**RESOLUTION MSC.75(69)
(adopted on 14 May 1998)**

**ADOPTION OF AMENDMENTS TO THE CODE ON INTACT STABILITY FOR ALL TYPES
OF SHIPS COVERED BY IMO INSTRUMENTS (RESOLUTION A.749(18))**

**AMENDMENTS TO THE CODE ON INTACT STABILITY FOR ALL TYPES OF SHIPS
COVERED BY IMO INSTRUMENTS (RESOLUTION A.749(18))**

Figure 2.2.1

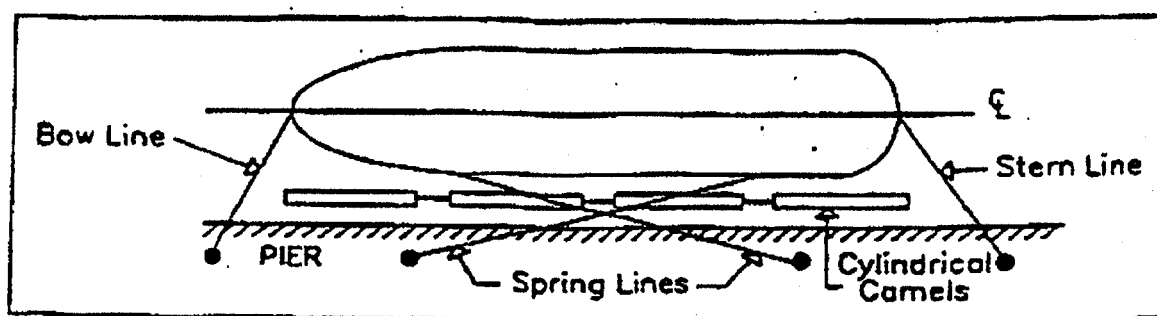
86 The existing text of section 2.2 "Mooring arrangements" is replaced by the following:

2.2.1 The mooring arrangement should ensure that the ship will be free to list without restraint for a sufficient period of time to allow a satisfactory reading of the heeling angle, due to each weight shift, to be recorded.

2.2.2 The ship should be held by lines at the bow and the stem, attached to bollards and/or cleats on the deck. If suitable restraint of the ship cannot be achieved using deck fittings, then temporary padeyes should be attached as close as possible to the centreline of the ship and as near the waterline as practical. Where the ship can be moored to one side only, it is good practice to supplement the bow and stern lines with two spring lines in order to maintain positive control of the ship, as shown in figure 2.2.1. The leads of the spring lines should be as long as practicable. Cylindrical camels should be provided between the ship and the dock. All lines should be slack, with the ship free of the pier and camels, when taking readings.

2.2.2.1 If the ship is held off the pier by the combined effect of the wind and current, a superimposed heeling moment will act on the ship throughout the test. For steady conditions this will not affect the results. Gusty wind or uniformly varying wind and/or current will cause these superimposed heeling moments to change, which may require additional test points to obtain a valid test. The need for additional test points can be determined by plotting test points as they are obtained.

2.2.2.2 If the ship is pressed against the fenders by wind and/or current, all lines should be slack. The cylindrical camels will prevent binding but there will be an additional superimposed heeling moment due to the ship bearing against the camels. This condition should be avoided where possible but, when used, consideration should be given to pulling the ship free of the dock and camels and letting the ship drift as readings are taken.

2.2.2.3 Another acceptable arrangement is where the combined wind and current are such that the ship may be controlled by only one line at either the bow or the stern. In this case, the control line should be led from on or near the centre line of the ship with all lines but the control line slack, the ship is free to veer with the wind and/or current as readings are taken. This can sometimes be troublesome because varying wind and/or current can cause distortion of the plot.
